Project	Creekview Ranch School Campus Expansion – Site Package
Client	Dry Creek Joint Elementary School District
Date	07/21/2026
Project Number	Y2514.00
Agency Number	02-123892 Inc. 01

End of Addendum Number 03

Exhibit A

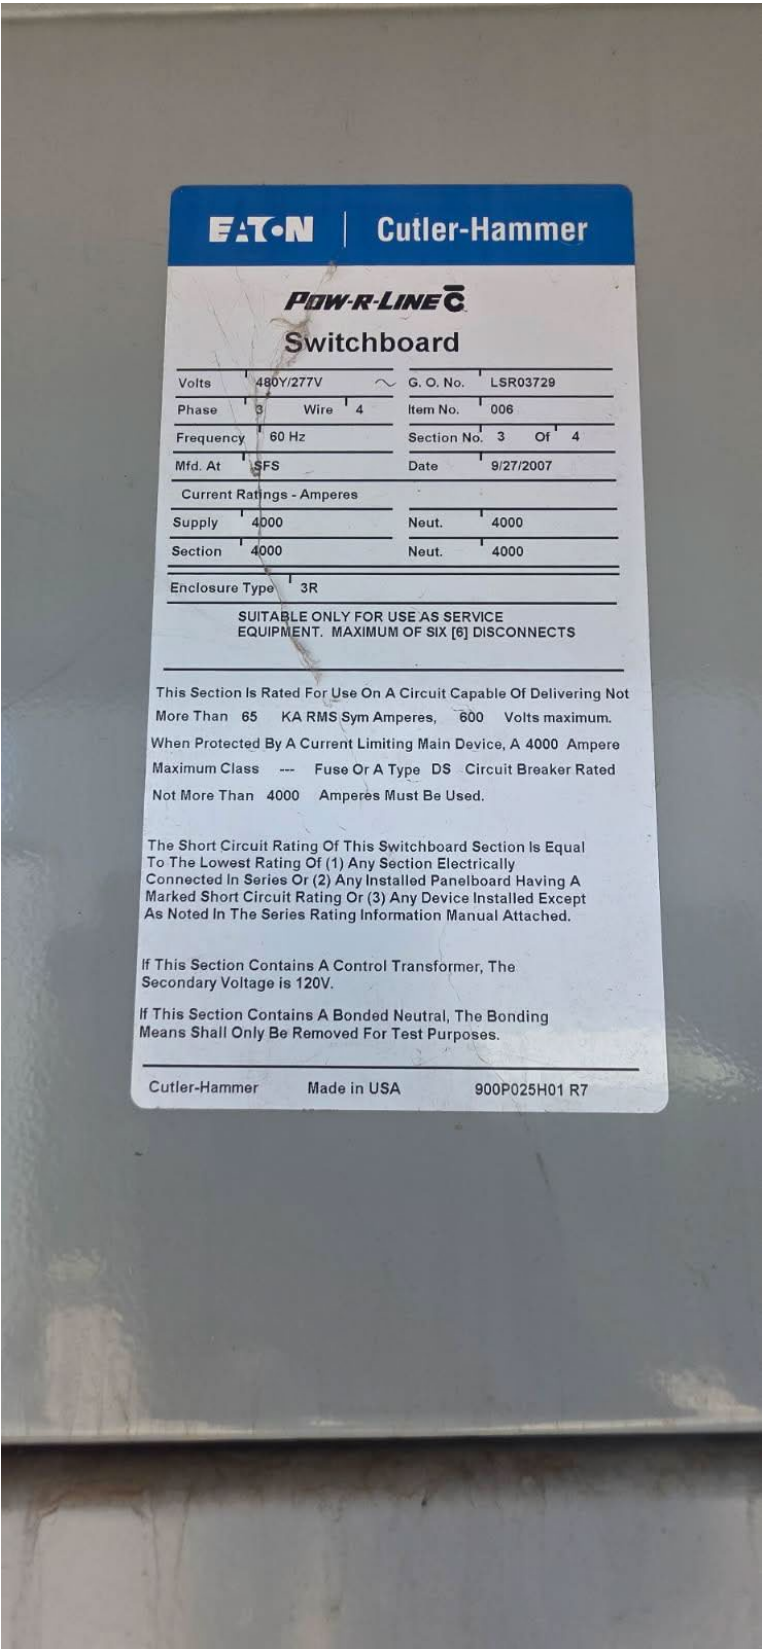
Q#2: Please provide additional information regarding the existing Main Switchboard (MSB), including available as-built drawings, manufacturer, model number, bus rating, breaker information, and any other relevant details necessary for coordinating modifications to the existing equipment.

R#2: EATON – Cutler Hammer Pow-R-Line Switchboard – 480Y/277V, 3PH. Panel ID attached. Contractor to verify any other relevant equipment on site prior to bid. Coordinate with owner to access site.

L4.3
AD3.05

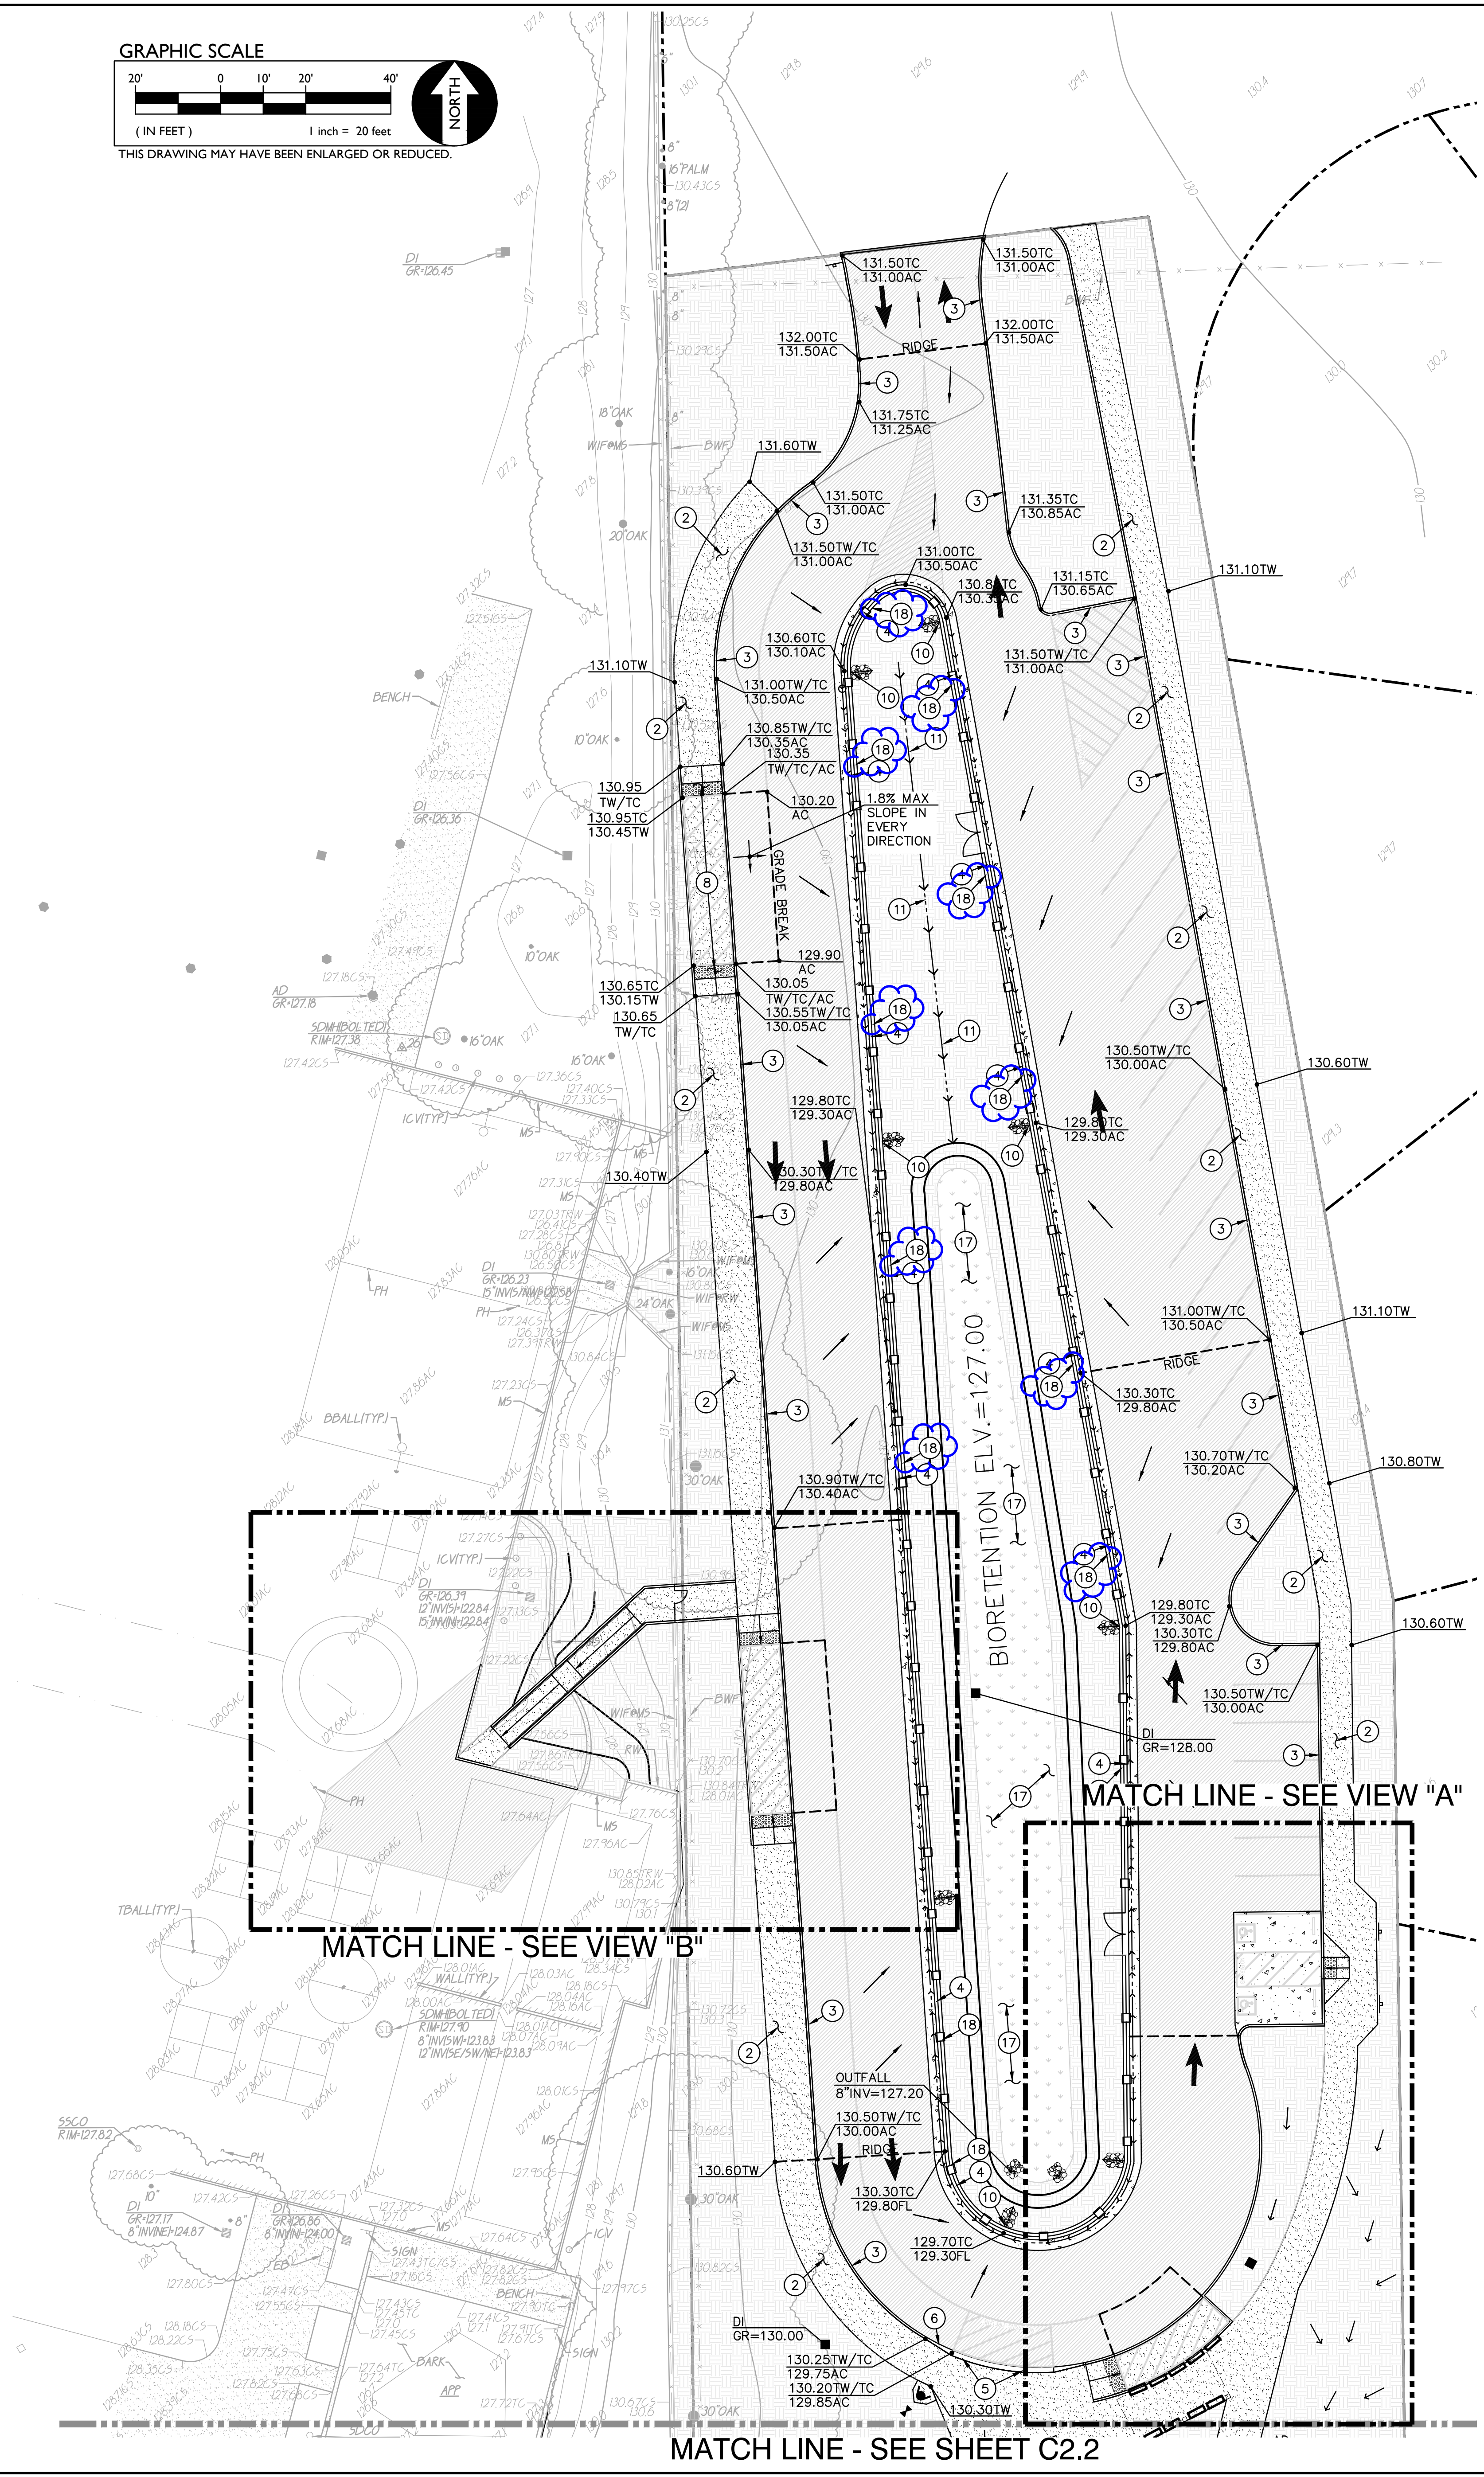
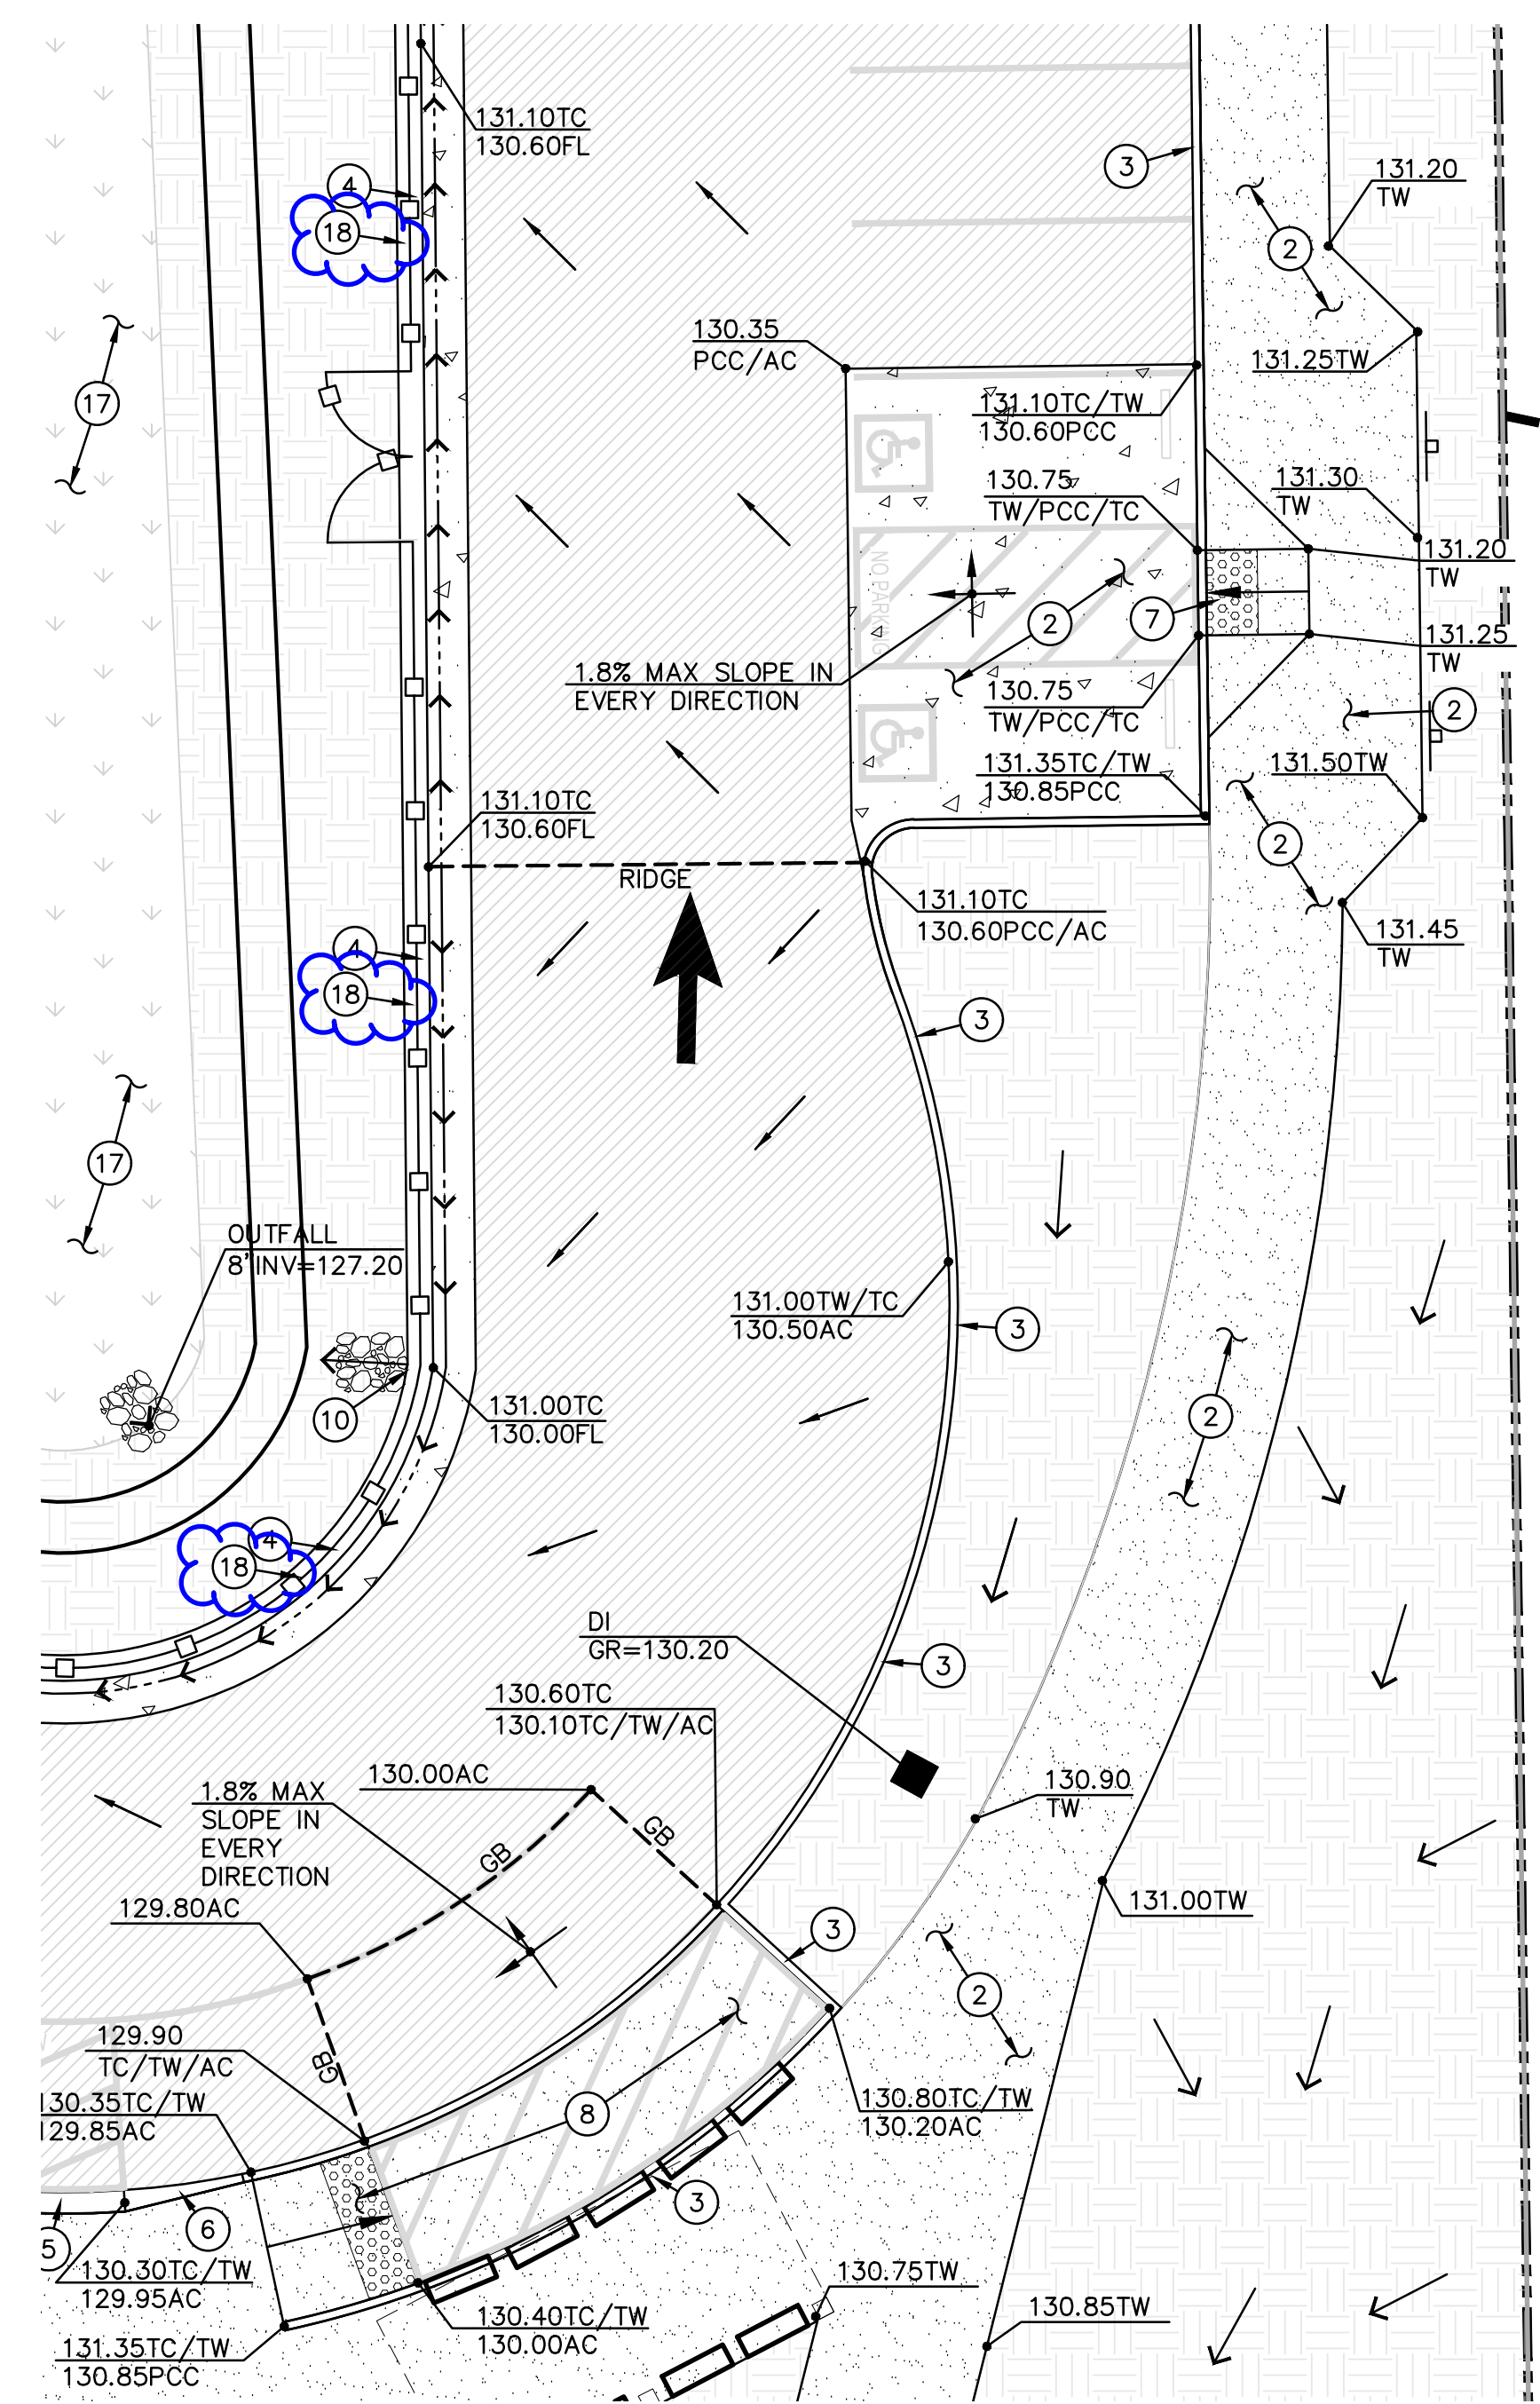
Q#11: According to Sheet L3.1, the irrigation legend indicates that 2-inch and 3-inch mainlines shall use Leemco fittings. However, Specification Section 328000, Part 2.02 states that 2-inch and smaller mainlines shall use Schedule 40 PVC fittings. Please clarify which requirement governs.

Q#12: Please provide the material type and size for the flush valve shown in the irrigation legend on Sheet L3.1.

R#11: Drawings updated to show Schedule 40. See attached drawings.

R#12: Flush valve shall be 1/2" plastic ball valve.

- AD3.03** Sheet L3.1 – Sprinkler Irrigation Plan
- Update all Leemco piping to PVC Schedule 40
- AD3.04** Sheet L4.2 – Sprinkler Irrigation Details
- Remove Detail 2, Detail 3, Detail 4, Detail 5, Detail 6, Detail 7
 - Update Detail 8
- AD3.05** Sheet L4.3 – Sprinkler Irrigation Details
- Update Detail 1, Detail 2, Detail 3, Detail 4
- AD3.06** Sheet C2.1 – Grading Plan
- Added Keynote 18 and placed on all views
